Site Development Plan Parkview at Emerson Age Restricted Adult Housing-MIHU's

Section 3, Area 4, Parcel A-I 6th Election District Howard County, Maryland

reoline revision to upoate appress chart
10/27/08	\bigcirc	REDLINE REVISION TO REALIGN SWM FACILITY PER F-09-34
DATE	N/S	REVIGION

SDP-06-159

Plat No. or L/F Tax Map Elect. Dist. Zone

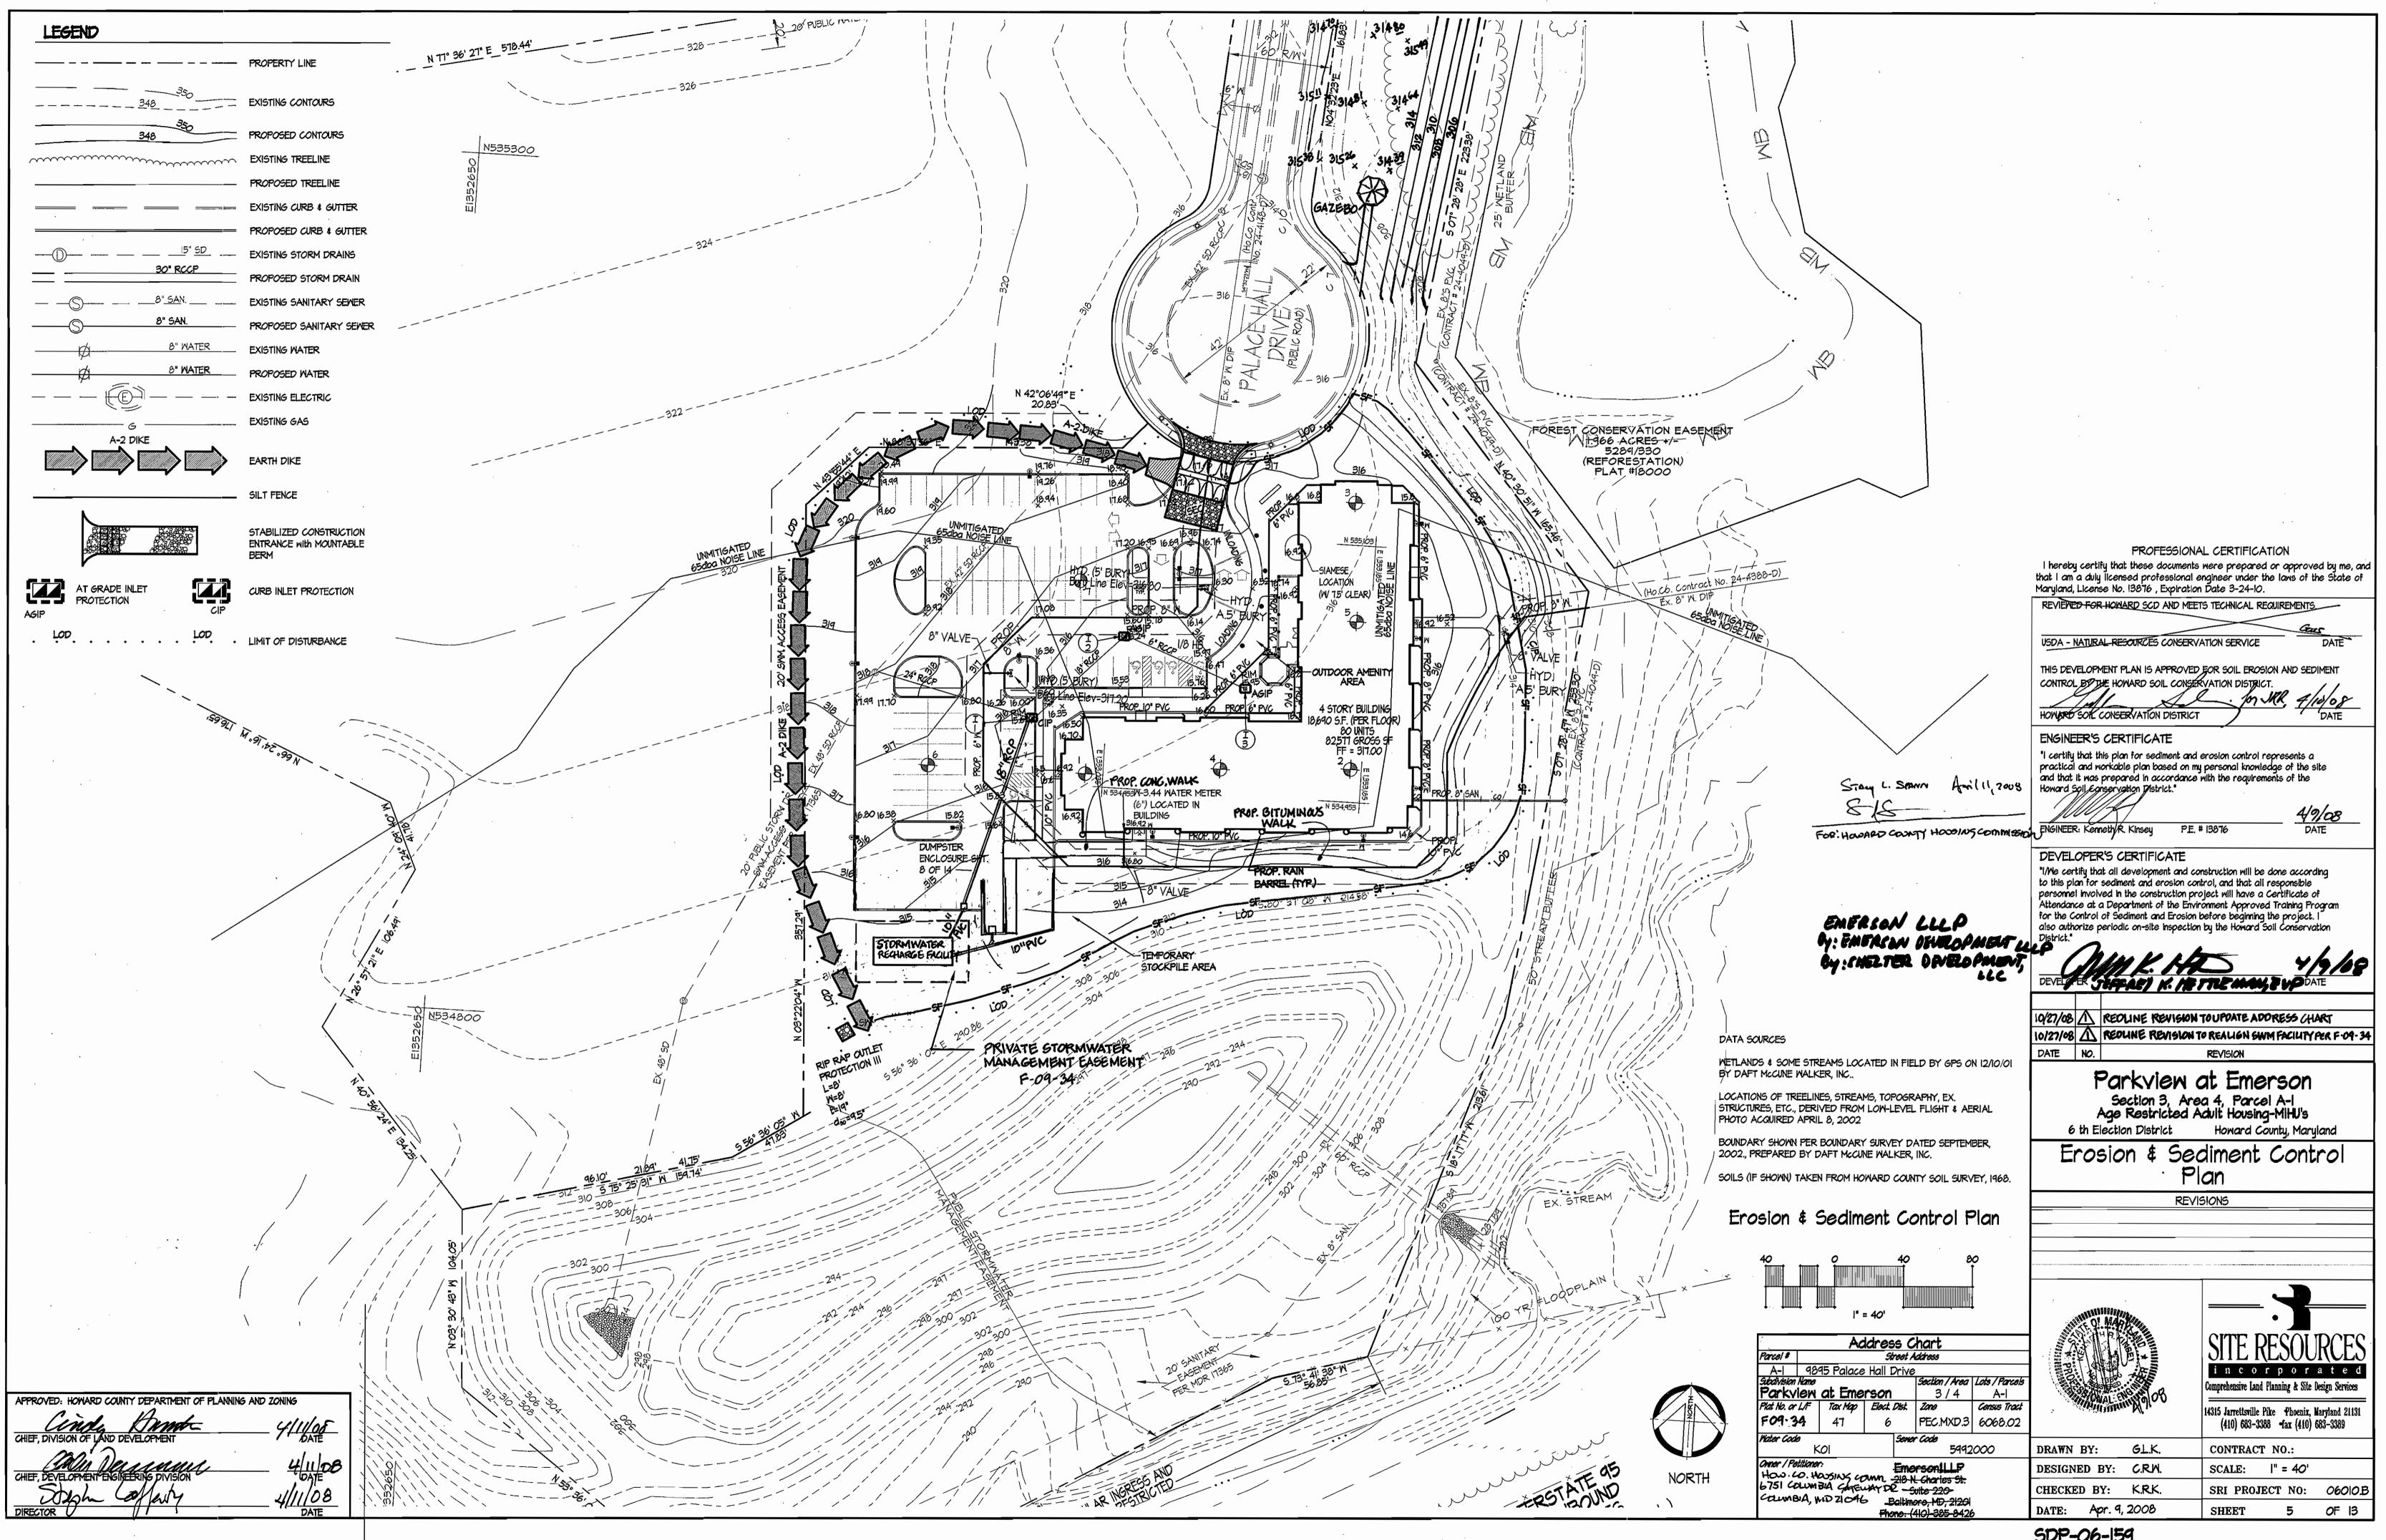
10/27/08 A REDLINE REVISION TO UPDATE ADDRESS CHART REVISE GENERAL NOTE \$24 PER FOO -34 PLAT OF REVISION DATE NO. REVISION
